RE: Revised Perc Cert Plan
Nursery View Lots 8 & 9
File No: F-10-87

RE: Plat of Resubdivision Review Comments
Nursery View Lots 8 & 9
File No: F-10-87

RE: F-10-87/Nursery View, Lots 8 and 9, Sec. 3

**RE: File Number: F-10-087
Nursery View Lots 8 & 9 Sec. 3
Old Frederick Rd**

PERCOLATION CERTIFICATION PLAN
 LANDS CONVEYED TO
HARRY RONALD DOVE, ET UX
 LIBER 10056 AT FOLIO 567
 LIBER 945 AT FOLIO 301
 17345 OLD FREDERICK ROAD
 FOURTH ELECTION DISTRICT
 HOWARD COUNTY, MARYLAND
 SCALE: 1" = 50' AUGUST 2009

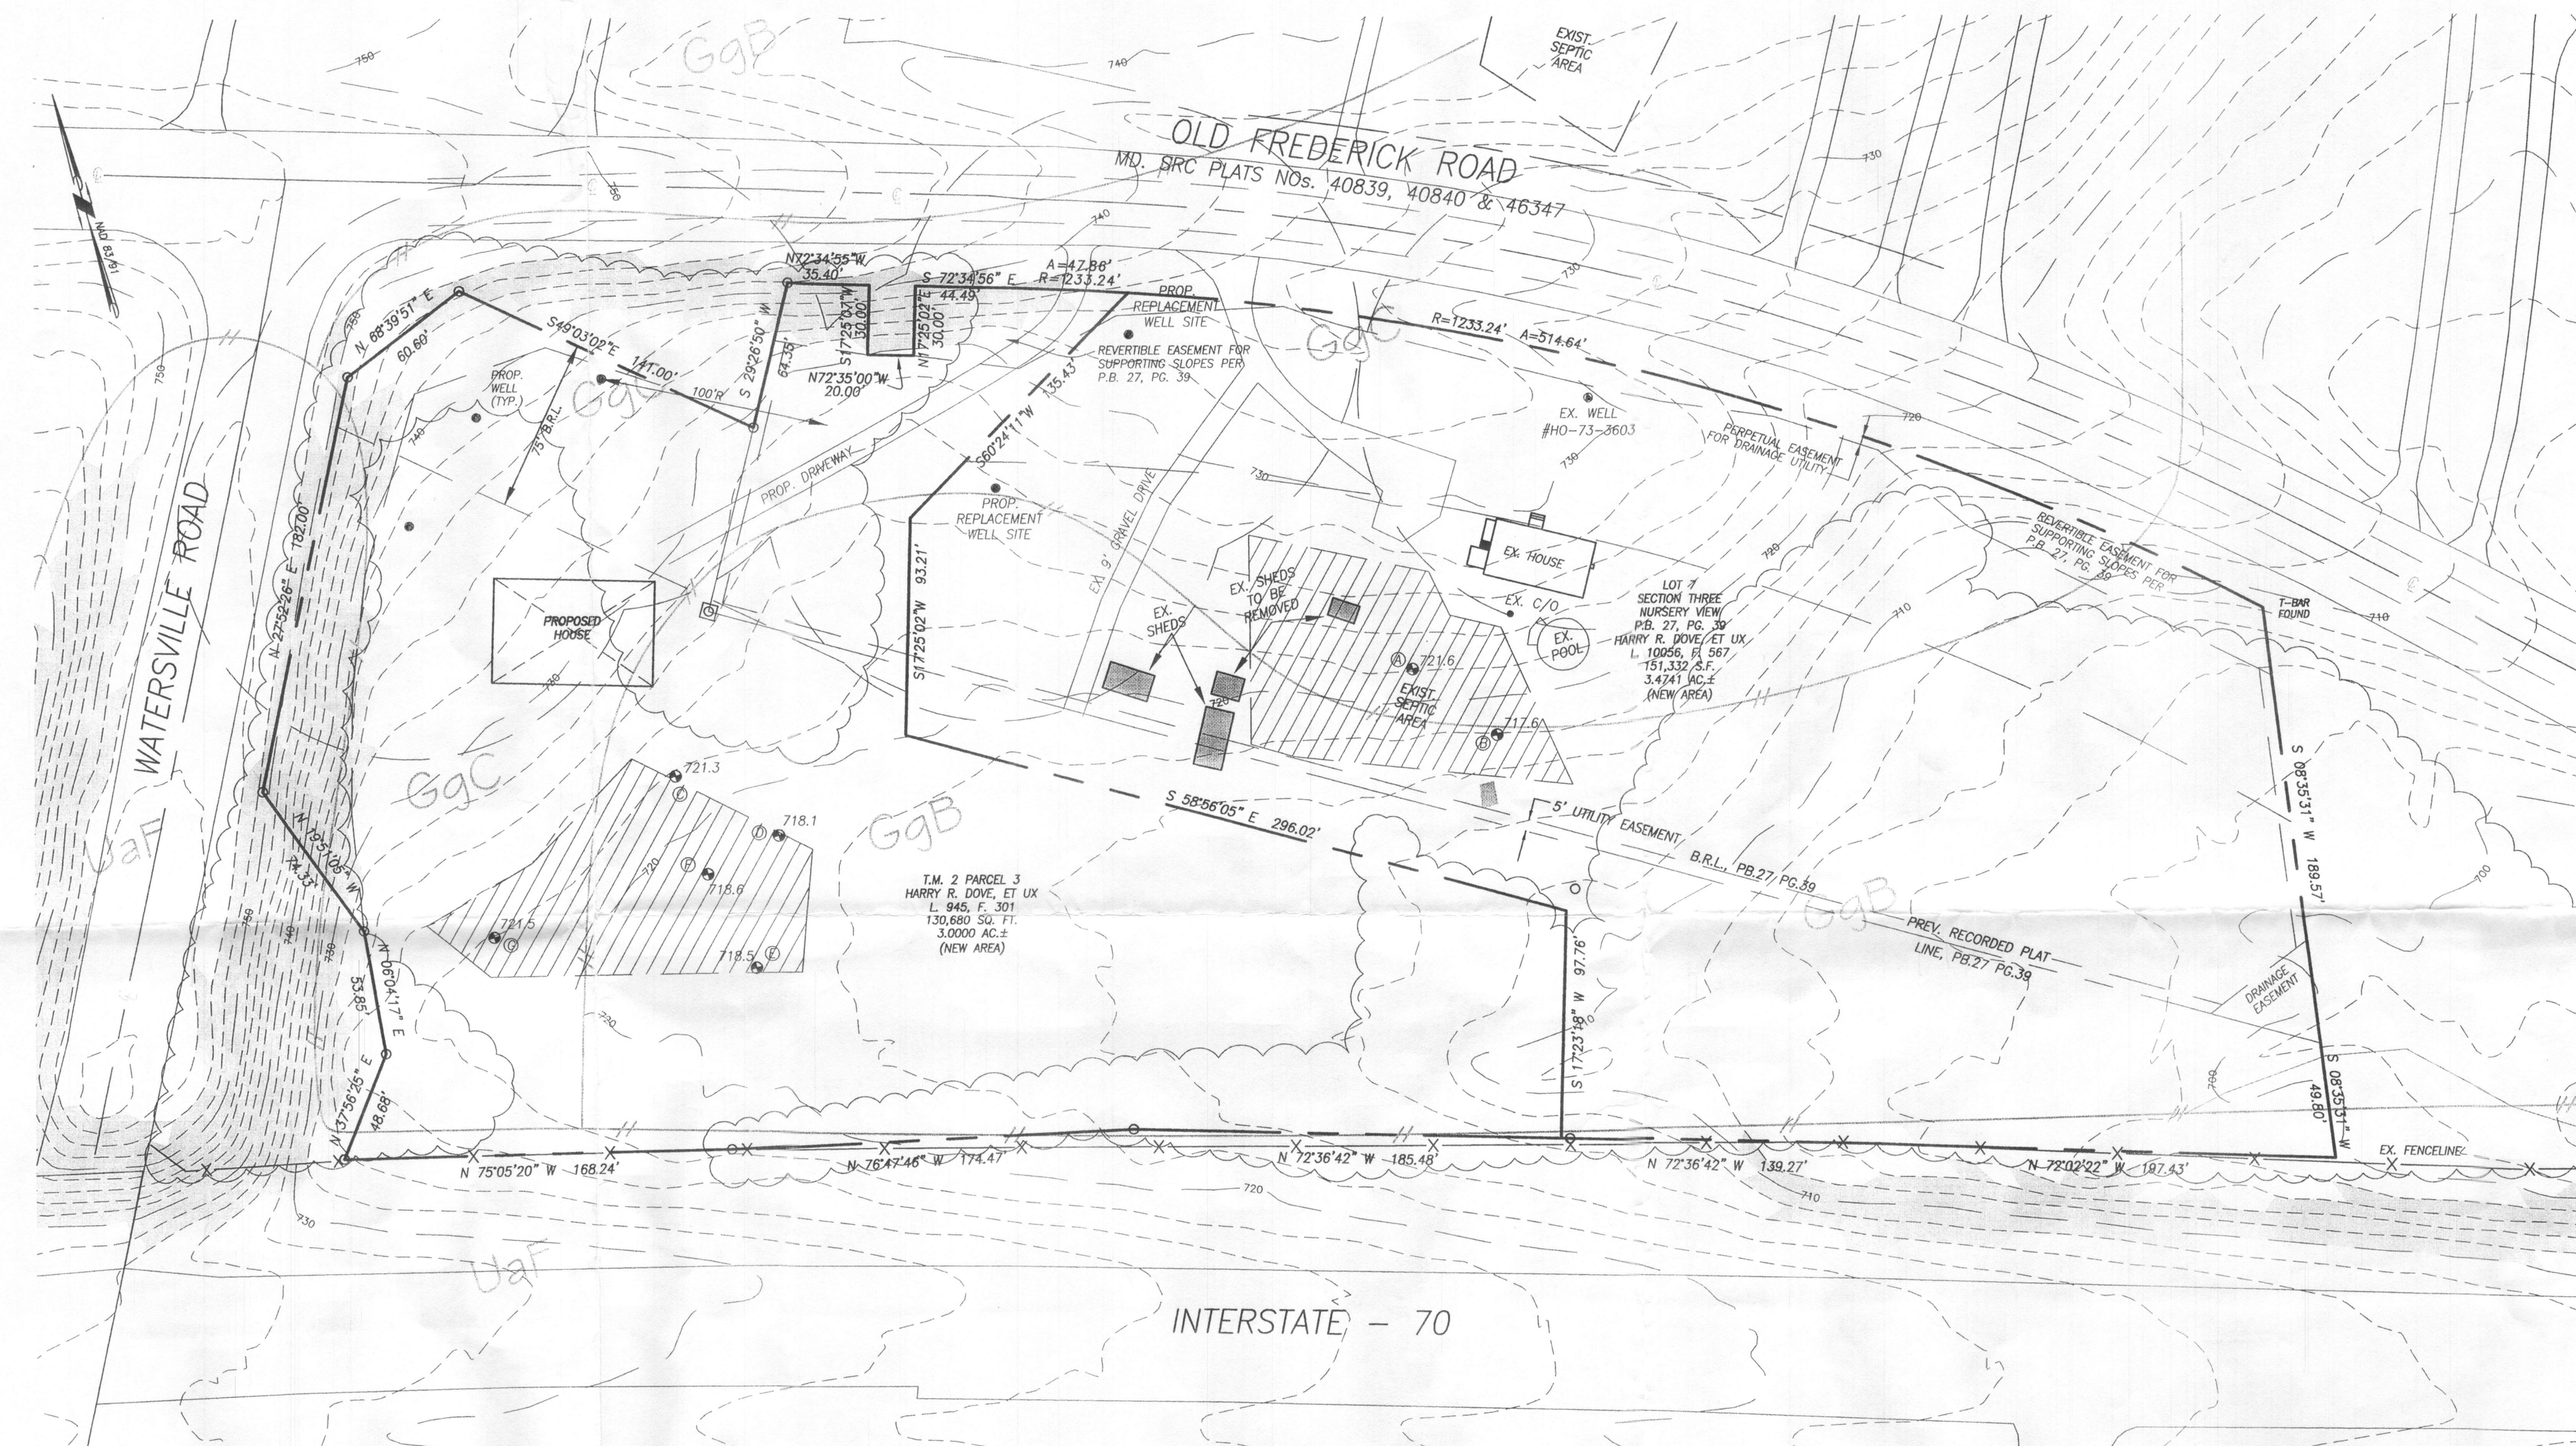
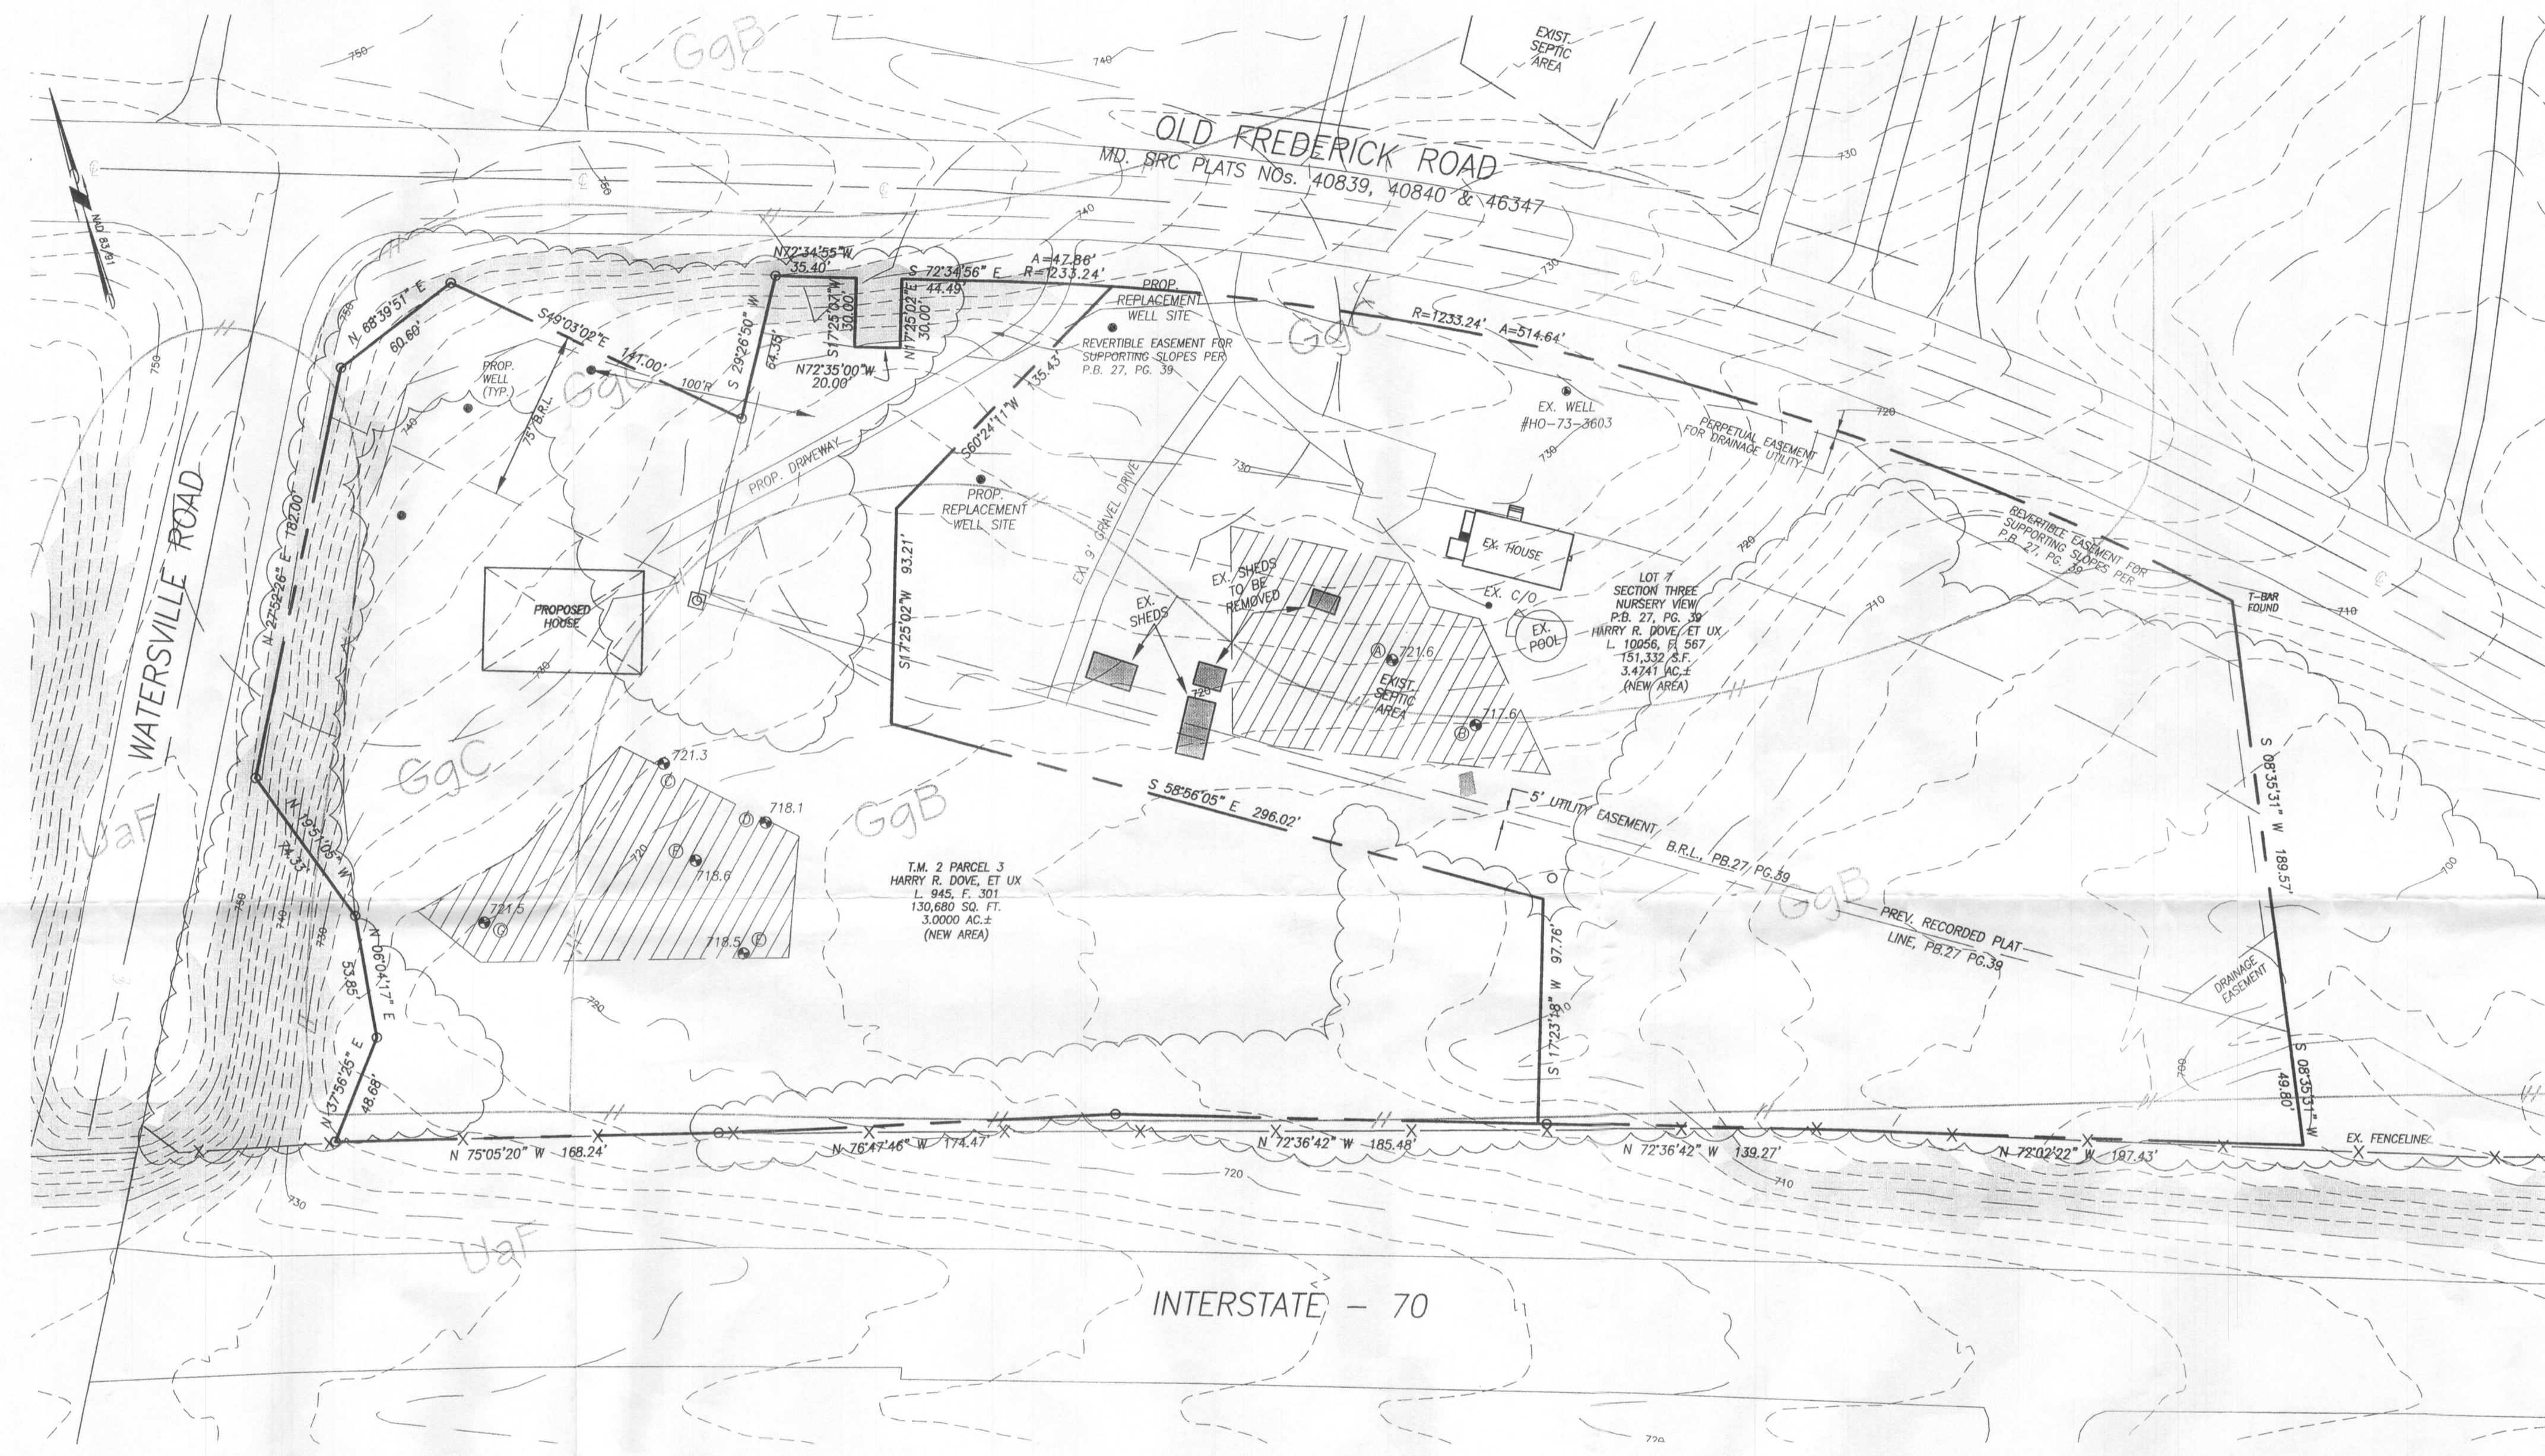
Further review of this project is contingent upon submission of a Percolation Certification Plan. The following items must be addressed on this plan:

- Show 2 additional replacement well sites for the existing house
- Show a proposed driveway for the proposed house.
- Remove failed percolation test symbol from legend.

- The well on Lot 9 must be drilled and documentation sent to the Health Dept.
- The existing well on Lot 8 must be tested for bacteria and nitrates (acknowledged, per comment #21)
- The existing structures labeled as such on the Perc Cert must be moved so that they do not encroach on the SDA

1. We acknowledge the well for Lot 9 must be drilled.
2. We acknowledge the existing well on Lot 8 must be tested; as you have indicated this is noted by Note 21.
3. We acknowledge the existing structures must be moved as indicated.
